Docket No. STN 52-001

Subject: **Submittal Supporting Accelerated ABWR Review Schedule - Reactor Systems
and Mechanical Engineering Branches Outstanding Items**

Enclosed are SSAR markups addressing: Open Items 5.3.2-1 and 15.3-1; and
Confirmatory Items 4.2-3 and 4.4-1.

Figure 4.2-1 Reference ABWR Control Rod Assembly

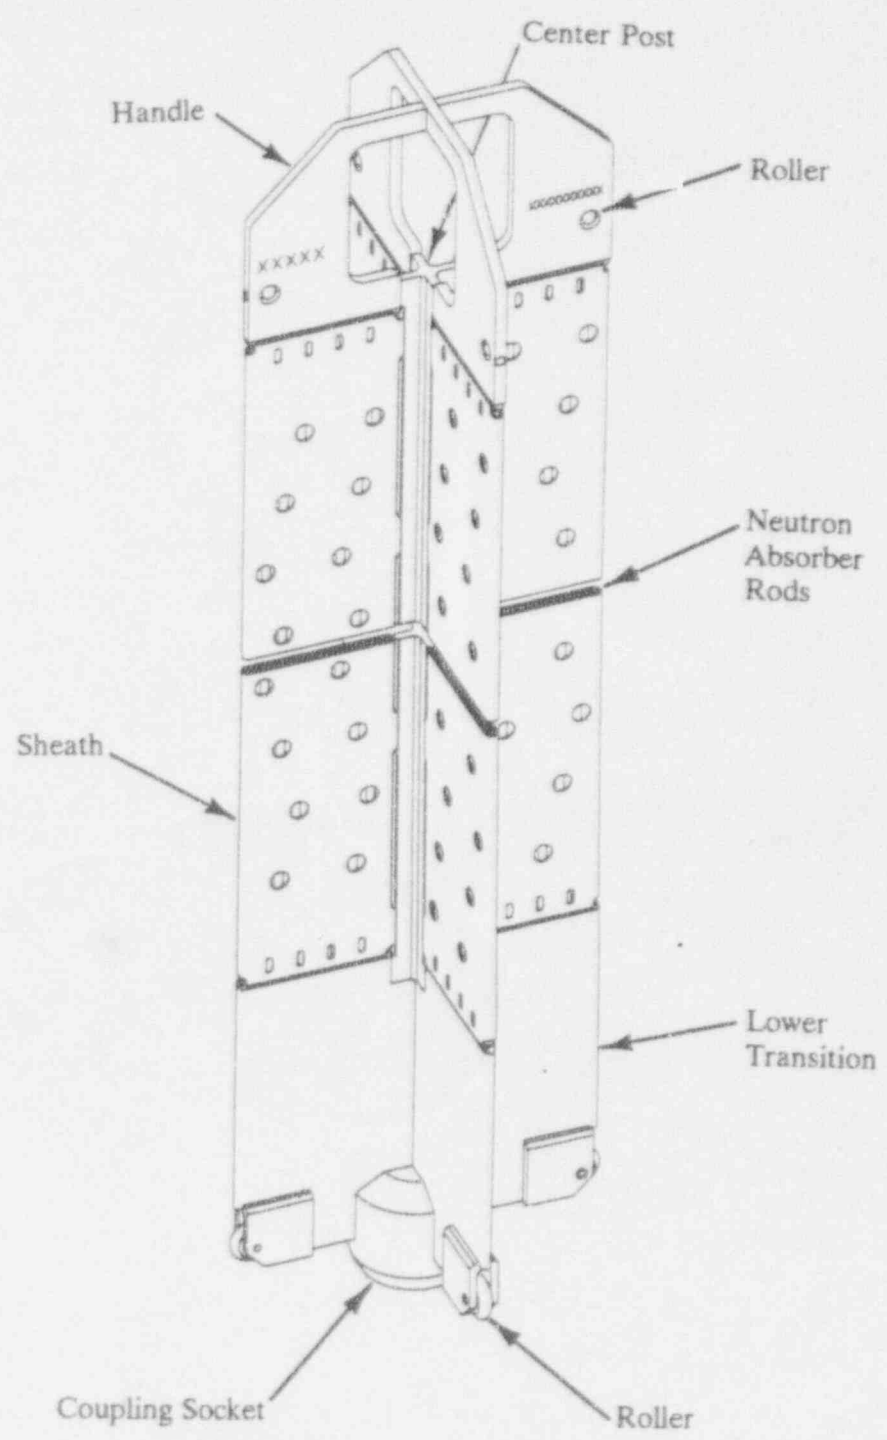
The reference ABWR control rod design consists of a sheathed cruciform array of stainless steel tubes filled with boron carbide (B_4C) powder. Figure 4.2-1 is an illustration of the reference design. The main structural members of the reference design are made of stainless steel and consist of a top handle, a lower transition piece with a control rod drive coupling, a vertical cruciform center post, and four U-shaped absorber tube sheaths. The top handle, lower transition piece and center post are welded into a single skeletal structure. The U-shaped sheaths are welded to the center post, handle, and lower transition piece to form the housing for the absorber rods filled with B_4C . Rollers at the top and bottom of the control rod guide the control rod as it is inserted and withdrawn from the core. The B_4C powder in the absorber tubes is compacted to approximately 70 percent of its theoretical density. The B_4C is sealed into the absorber tubes by plugs welded into each end, and is longitudinally separated into individual compartments by stainless steel balls. Typical parameters of the reference ABWR control rod design are provided in Table 4.2-1.

NEW
FIGURE 4.2-1

4.4-3
Figure 4.4-3 ABWR Stability

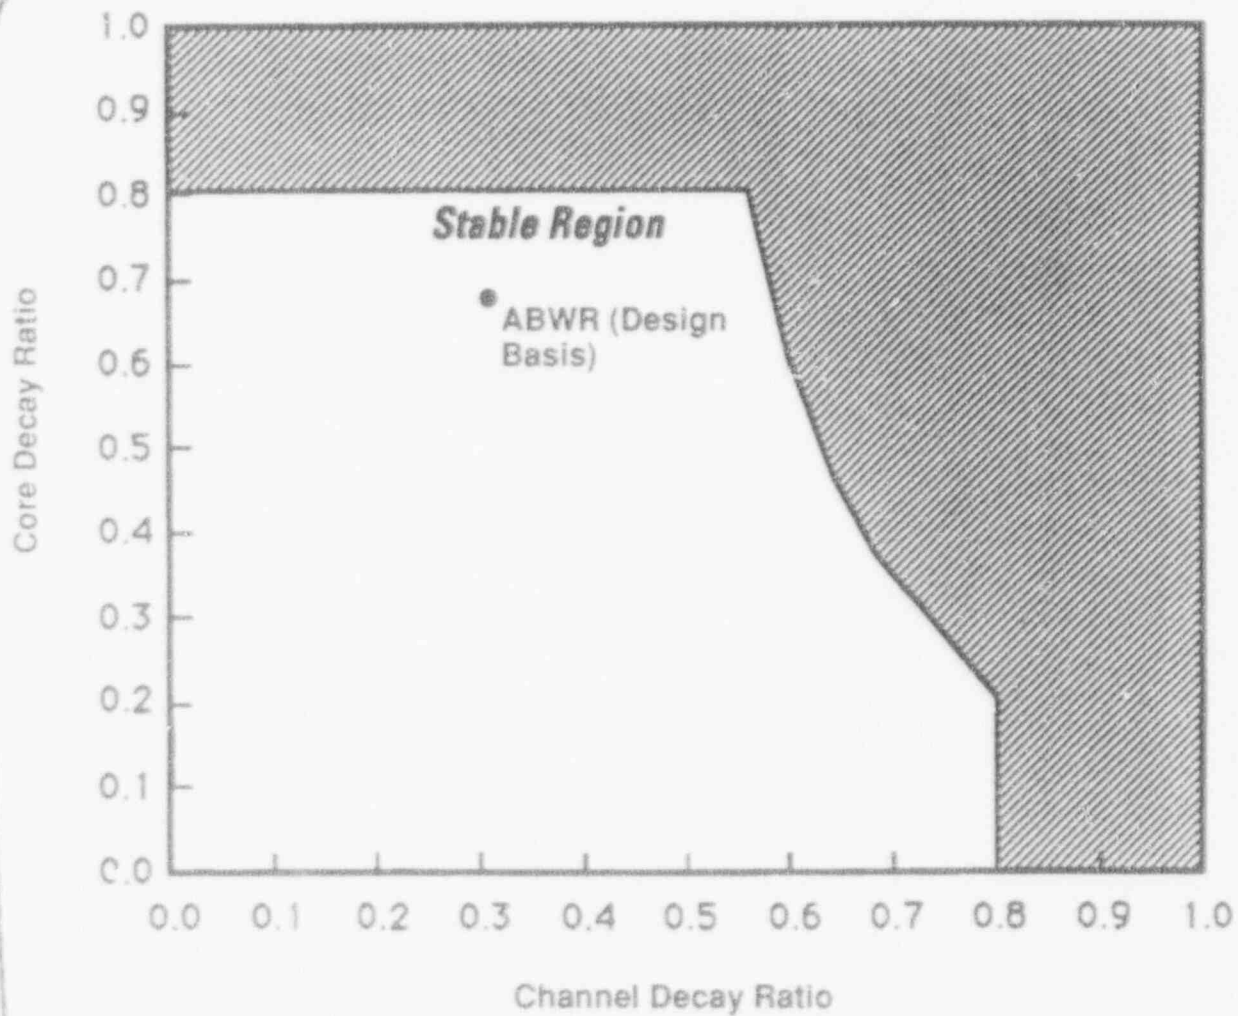
These results are also shown in Figure ~~X~~ together with the criteria. From Figure 1, it is confirmed that that ABWR is stable in the normal operating region.

CI 4.4-1

ABWR is stable in normal operating domain

4.4-4
Figure 4.4-4 Stability Controls and Protection Logic

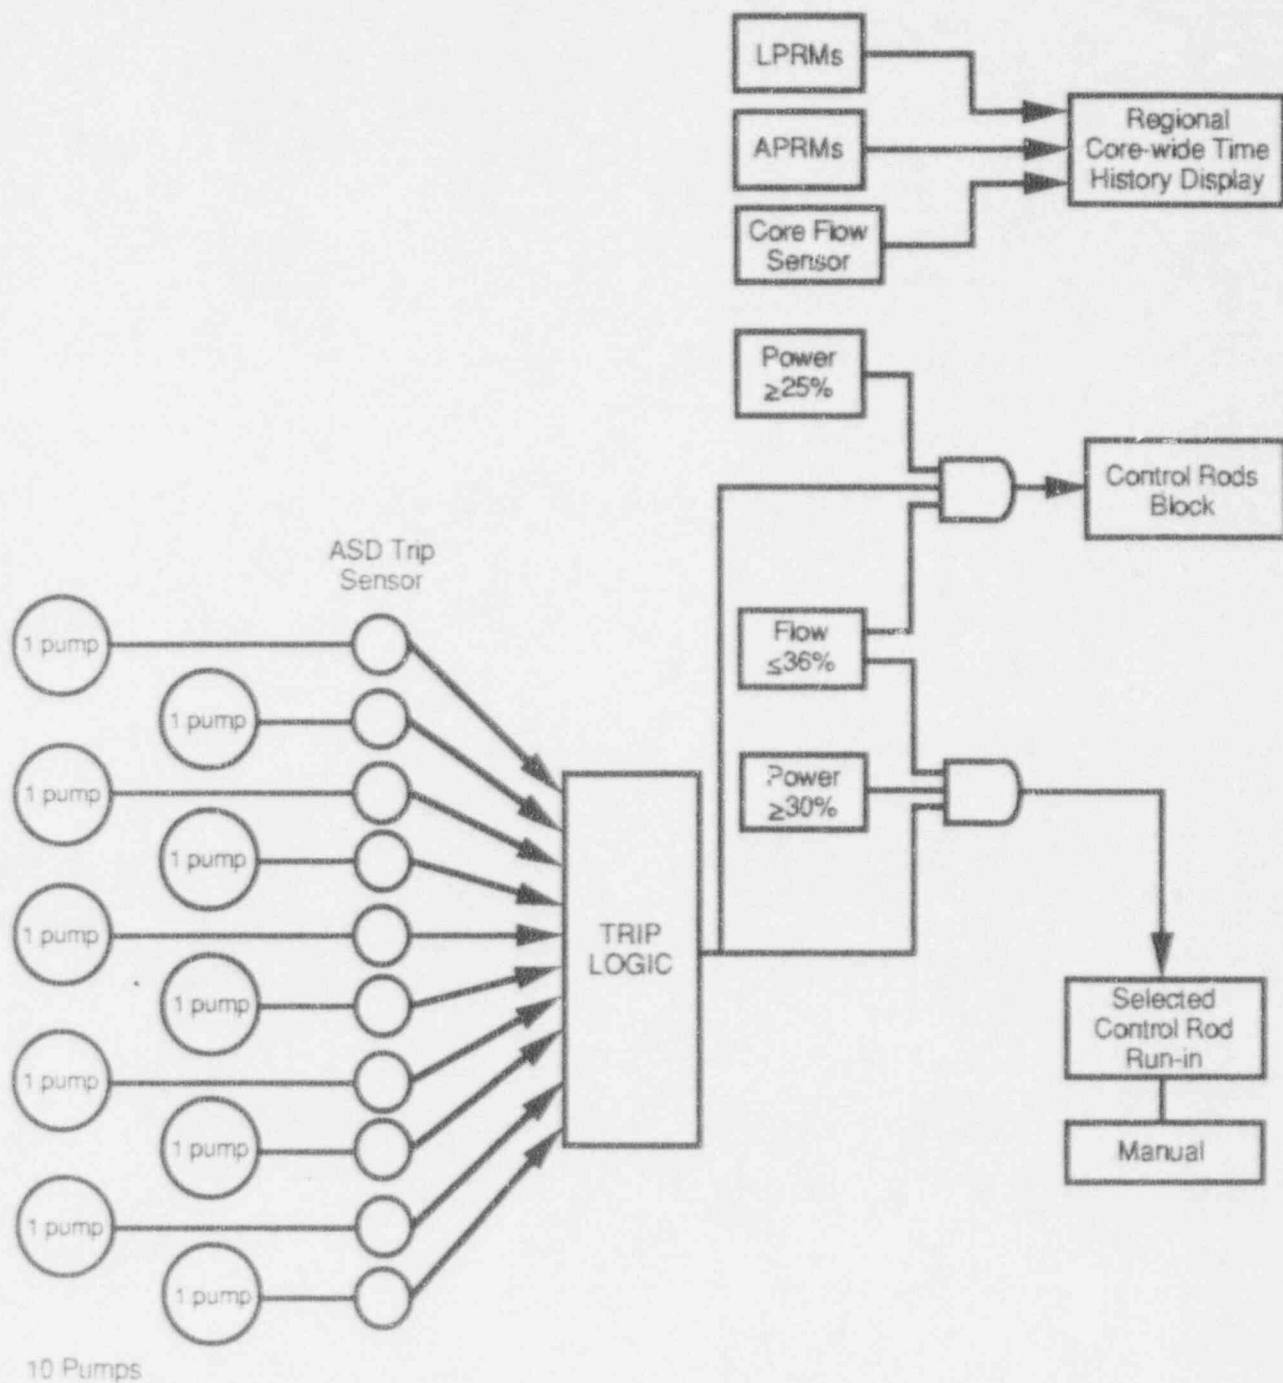
Furthermore, automatic logics (Figure ~~1~~) which prevent plant operation in the region with the least stability margin is also implemented. This design is similar to Option I-A, one of long-term solutions considered by the BWROG. In addition, in order to meet the stability design requirements specified in the ALWR Utility Requirements Document, Option III, LPRM based Oscillation Power Range Monitor (OPRM), which is also one of long-term solutions

1. Power $\geq 30\%$: To assure power level below 80% rod line at natural circulation.
2. Flow $\leq 36\%$: To assure flow rate is higher than that of eight RIPs operations with minimum pump speed

NEW FIGURE 4.4-4

5.3-3
Figure 3-4.2.2 Fast Neutron Flux as a Function of Water Thickness

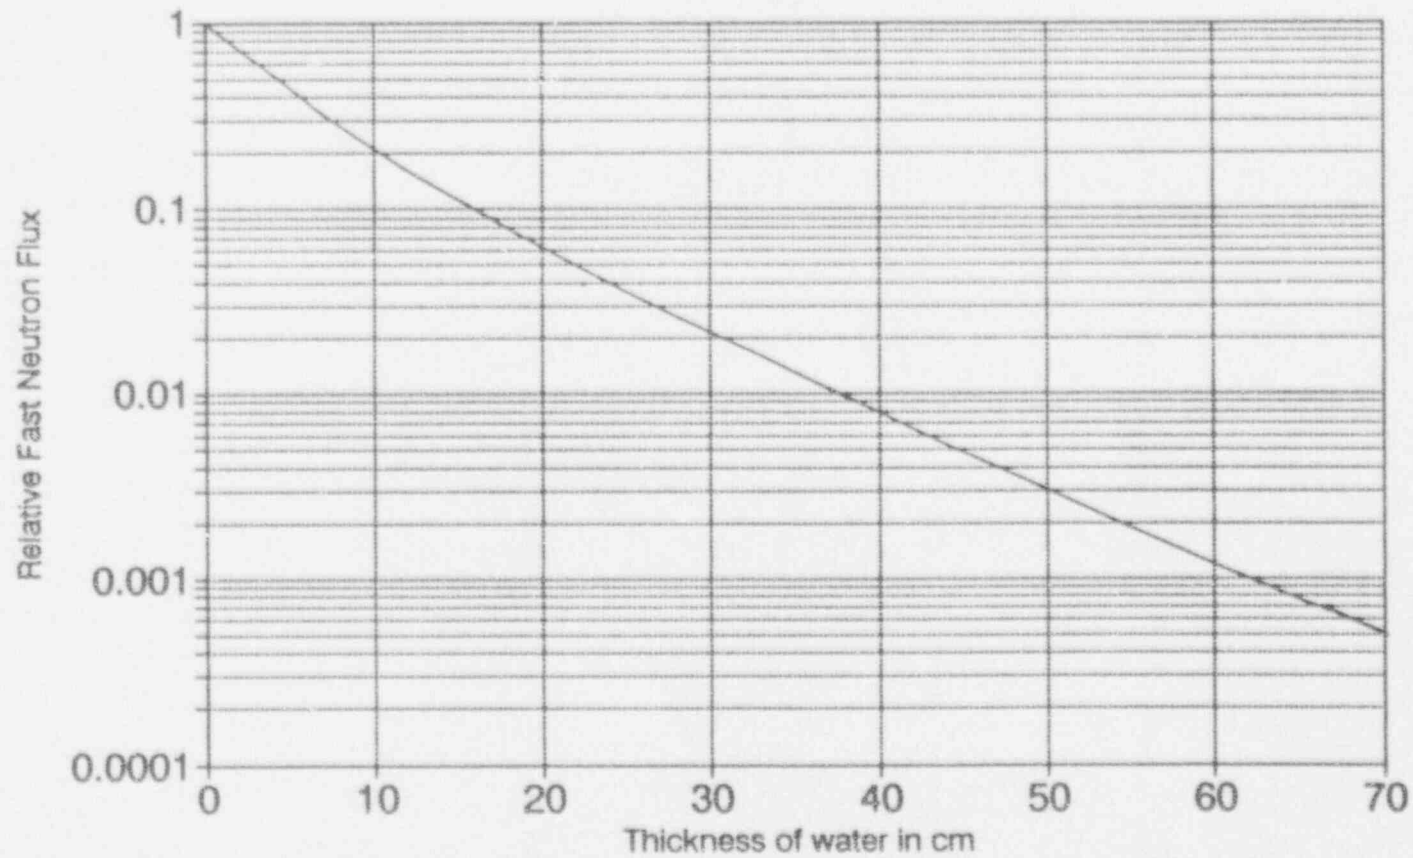
The evaluation of fast neutron fluence for the ABWR vessel was done using the Oak Ridge National Lab code DOT-4 on a CRAY X-MP Super Computer using an eighth core symmetry fixed source model. The neutron source was based upon a three dimensional nodal fuel model of ABWR for an integrated equilibrium core with a 26 group neutron spectrum. The results shown below are reasonable in comparison to the BWR/6 calculations which were performed with an older version of DOT. In this comparison, the BWR/6 40 year quarter thickness evaluations for the 218-624 plant were compared to the 40 year BWR/6 238-748 plant and the 40 year ABWR values which are shown on line three of ~~the table below~~ ^{Table 5.3-1}. In evaluating the relative fluence, the power level and shroud to vessel water thickness were taken into account. In the case of the water thickness, the neutron reduction factor was interpolated from ~~the attached figure~~ ^{Fig. 5-3} which shows the calculated fast neutron flux for an annular region as a function of water thickness. The incorporation of internal pumps increased the annulus between the shroud and the vessel wall for ABWR. This leads to an order of magnitude reduction in the expected fast fluence.

01 5.3.2-1
